STAFF REPORT  
KETCHUM PLANNING AND ZONING COMMISSION  
MEETING OF May 20, 2026

PROJECT: Wood River YMCA (Addition)

FILE NUMBER: P25-068A

APPLICATION: Design Review

SITE PLAN

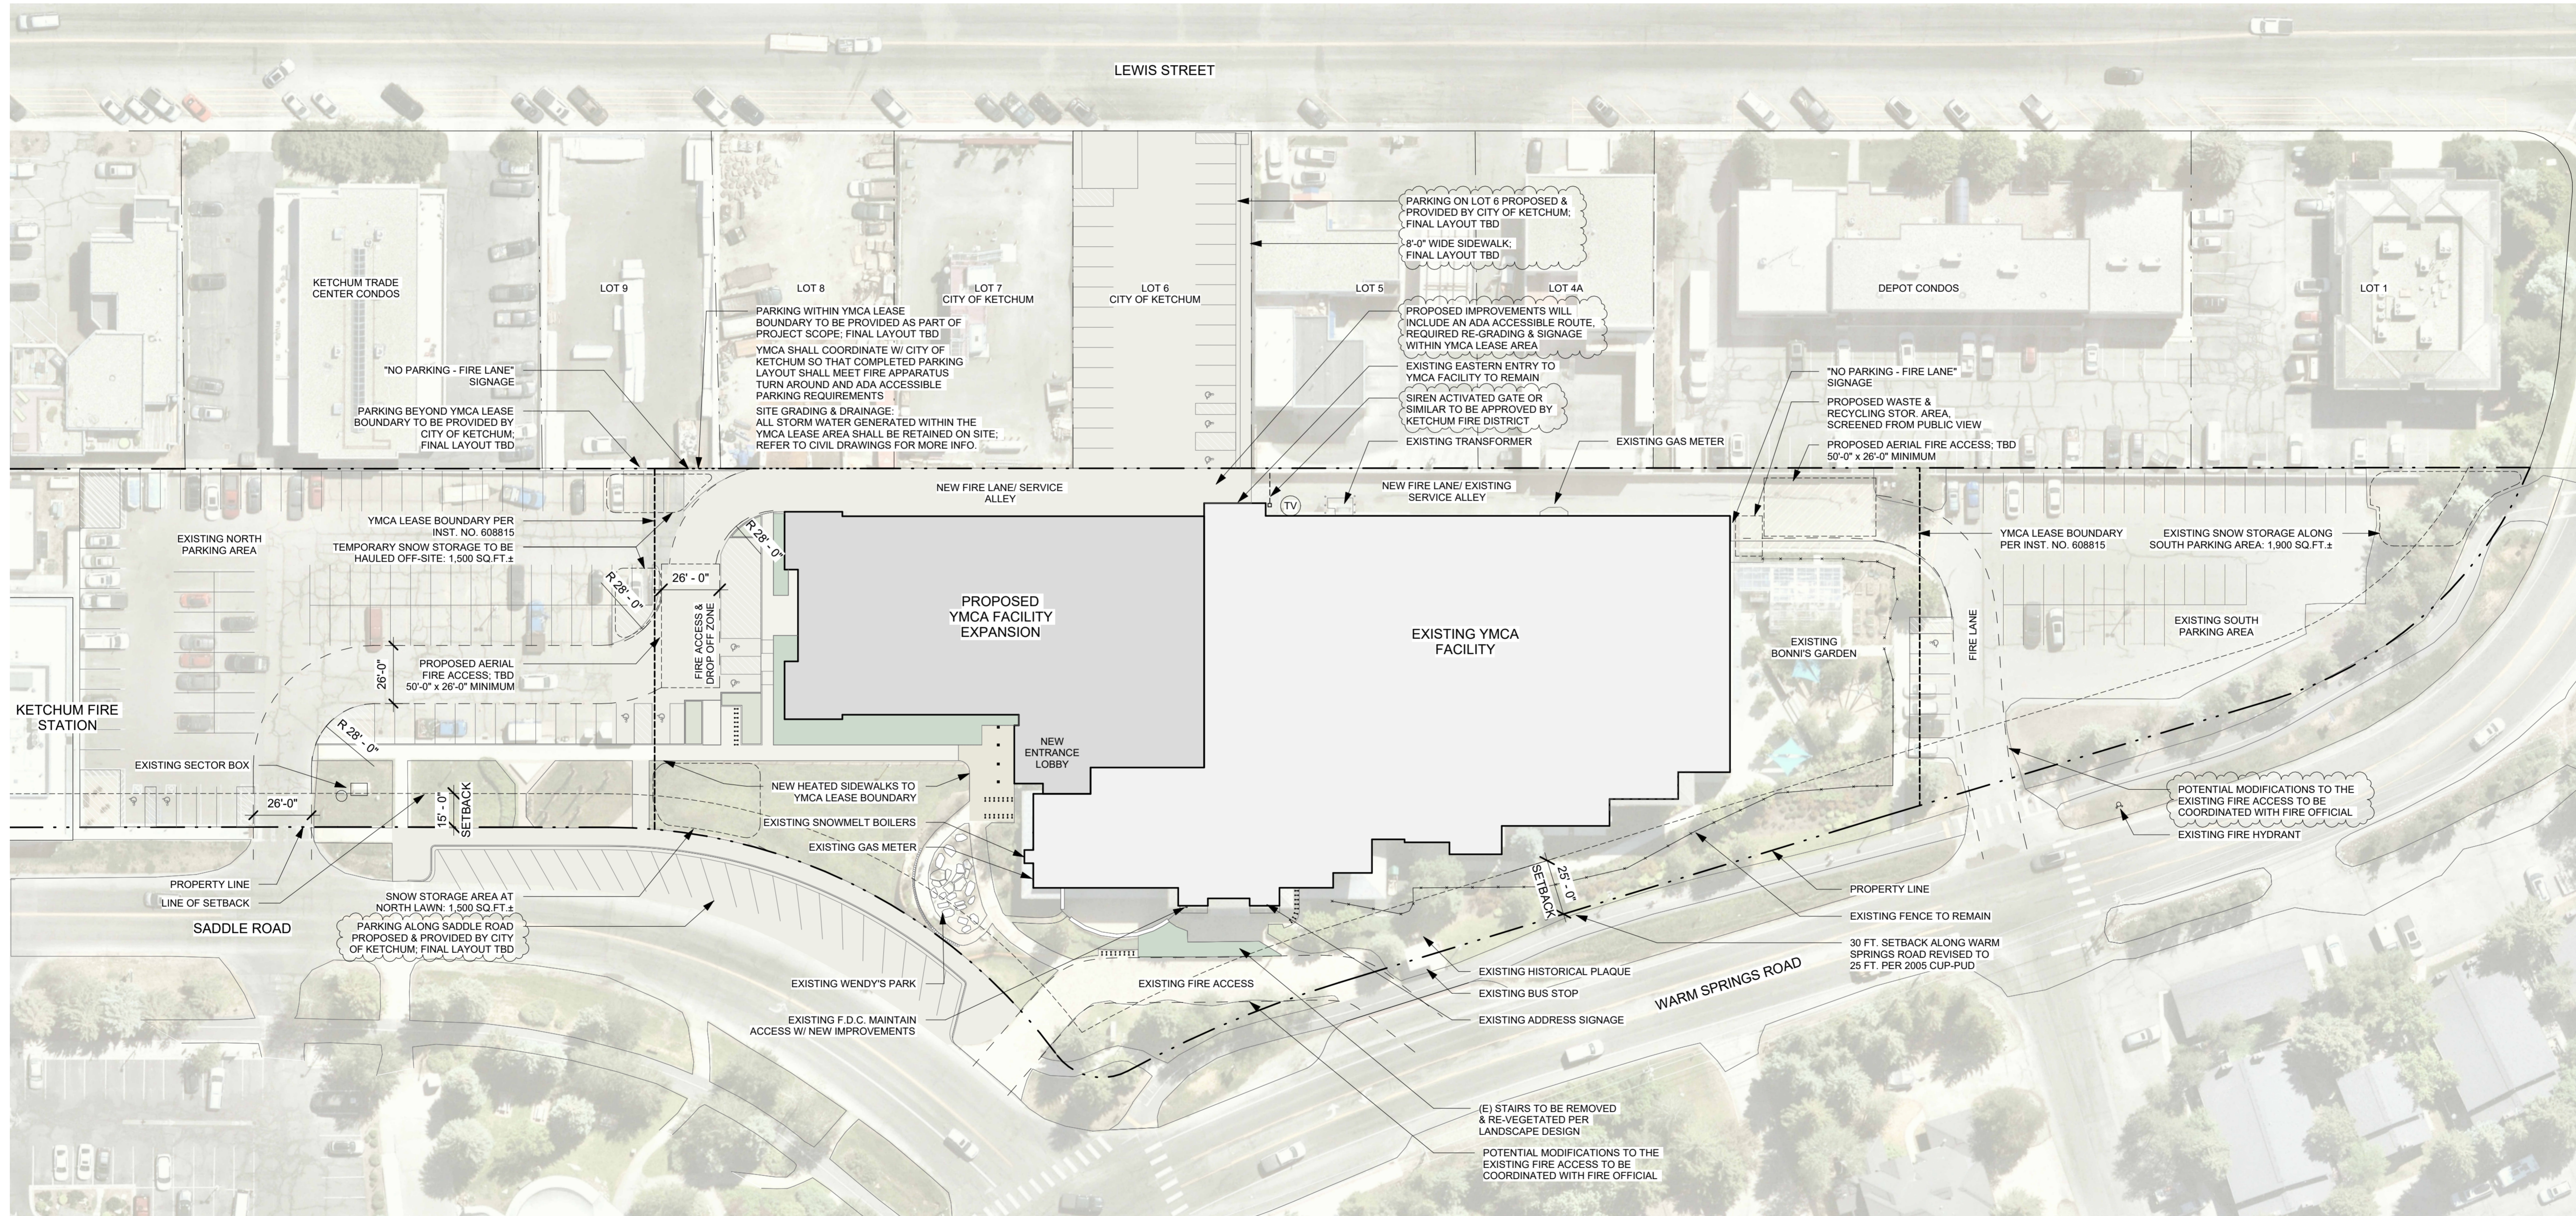
The garbage and recycling are located behind Bonnies Garden facing toward the rear alley and are screened from view. (See Attachment B: Sheet A1.1)

The Site Plan on Attachment B: Sheet C1.0 shows unobstructed access for fire and emergency vehicles. A fire lane of 26' hugs the northern portion of the structure and tapers to ~20' when servicing the rear of the structure. A siren activated gate is shown on Attachment B: Sheet A1.1. which could be accessed by emergency vehicles however a snowplow or other service vehicles would not be able to utilize this portion of

the alley and would have to back up quite aways in leu of a turnaround. Staff suggest a condition to change the siren activated gate to a manual obstruction to meet the need for both detracting passenger vehicles to and from the Lot 6 parking area but still allowing for the circulation of service vehicles when necessary. For example, a chain/roped off gate or something similar.

5. The siren activated gate shown within the plan set shall be replaced with a manually removable obstruction for access by service and snow removal vehicles.
6. In addition to the requirements set forth in this Design Review approval, this project shall comply with all applicable local, state, and federal laws.

ROOF PLAN

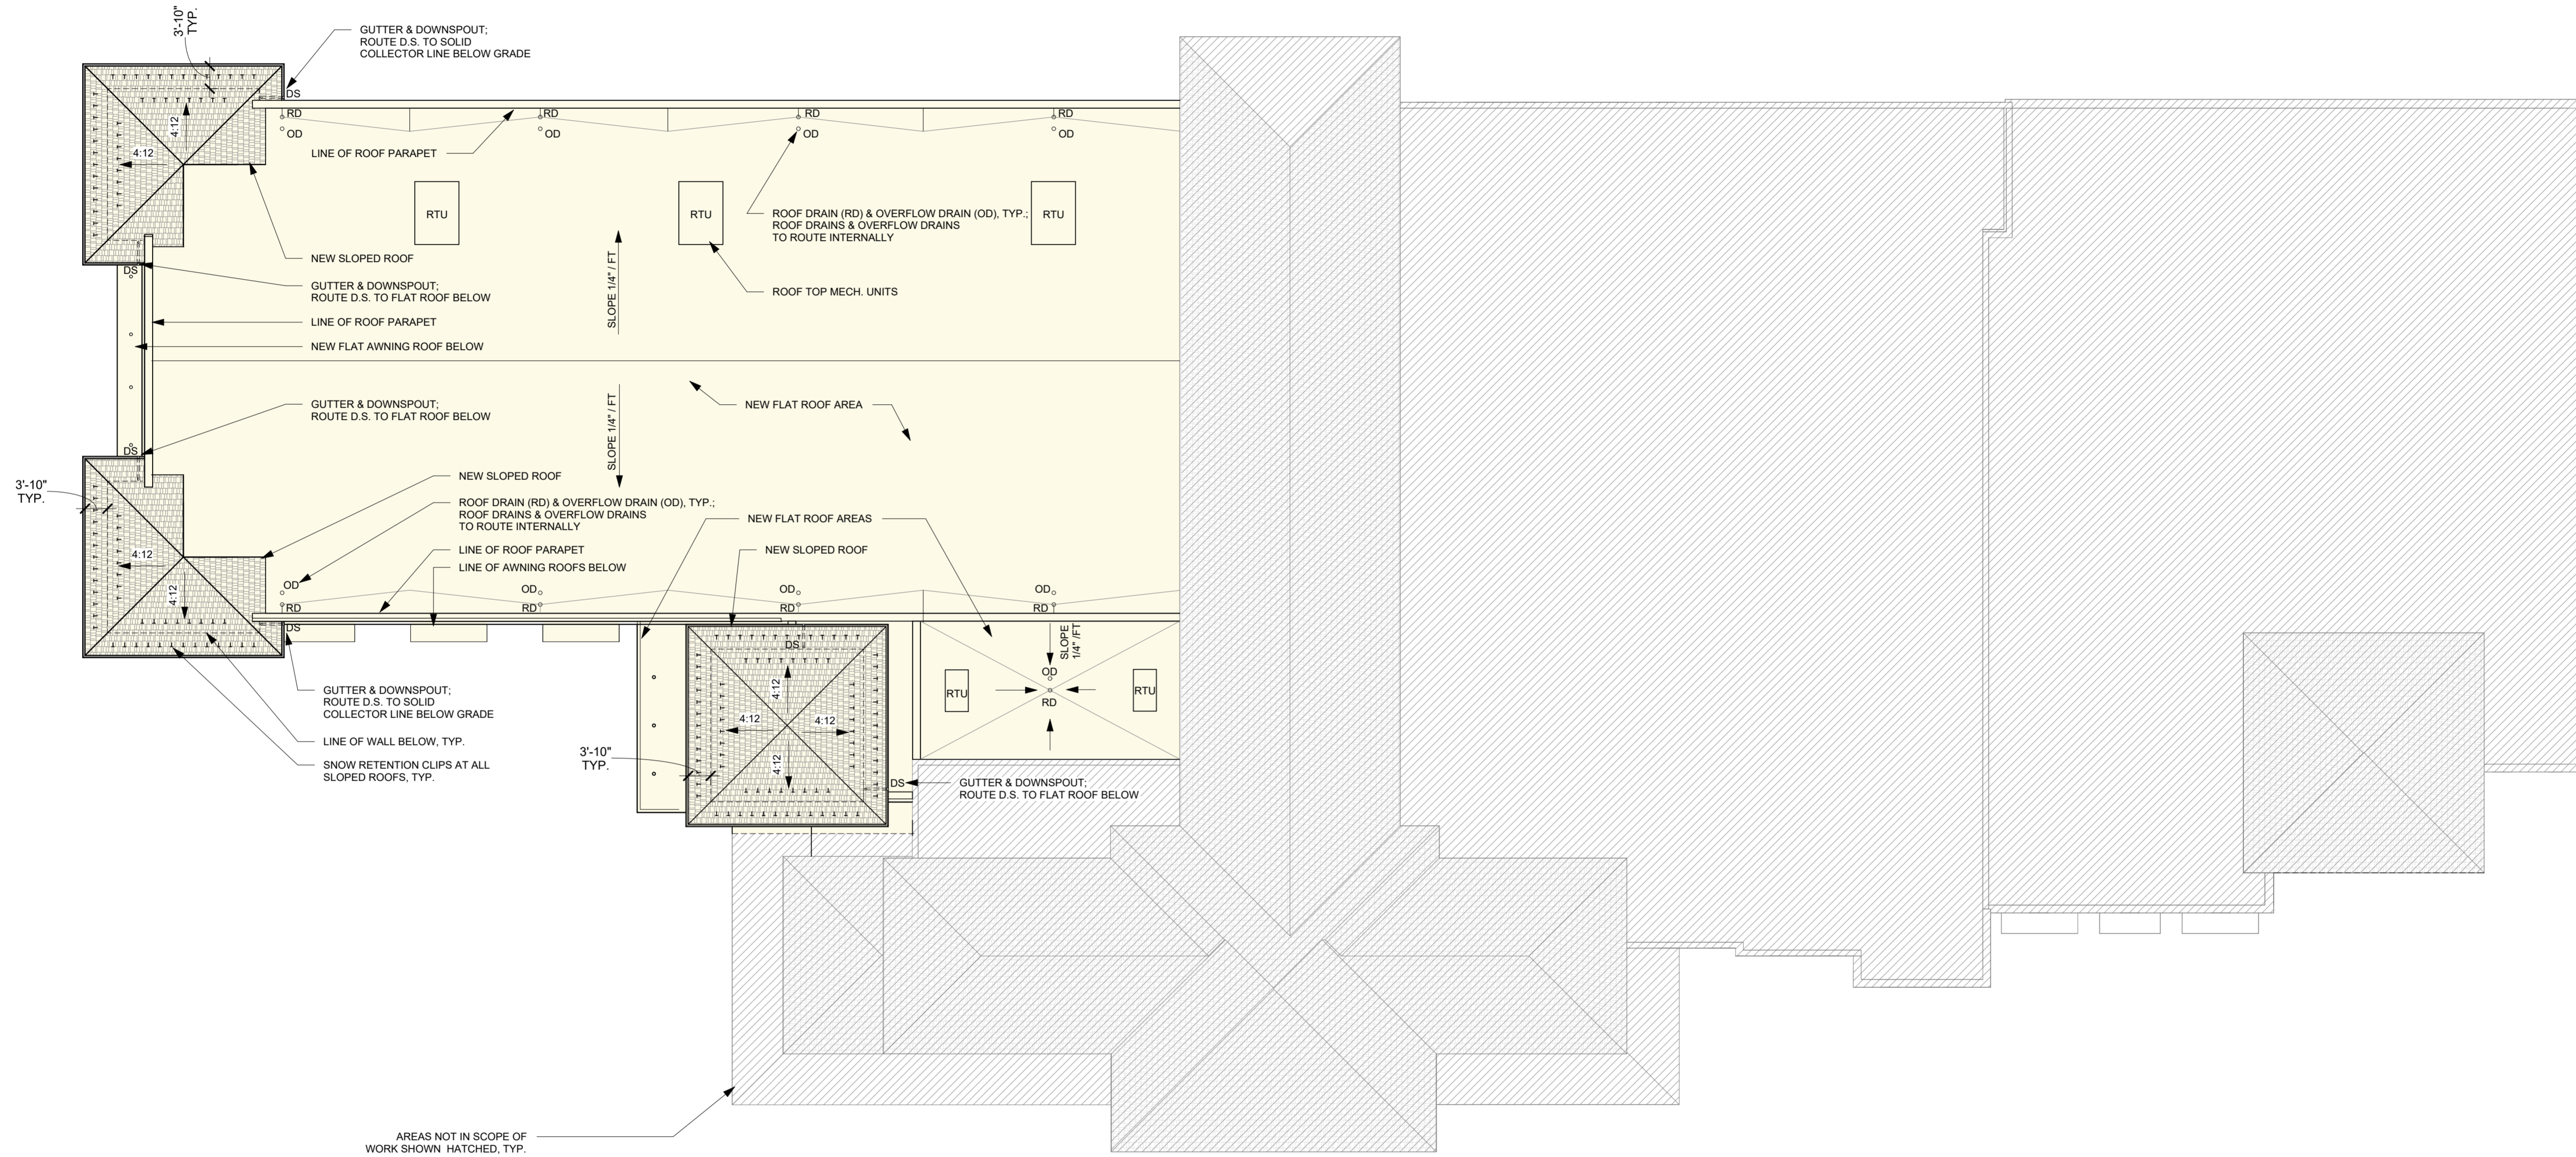
The front lobby has a large flat roof over the entrance. The three sloped roofs have snow retention clips to help mitigate snow slide. (See Attachment B: Sheets A2.1 & A2.2)
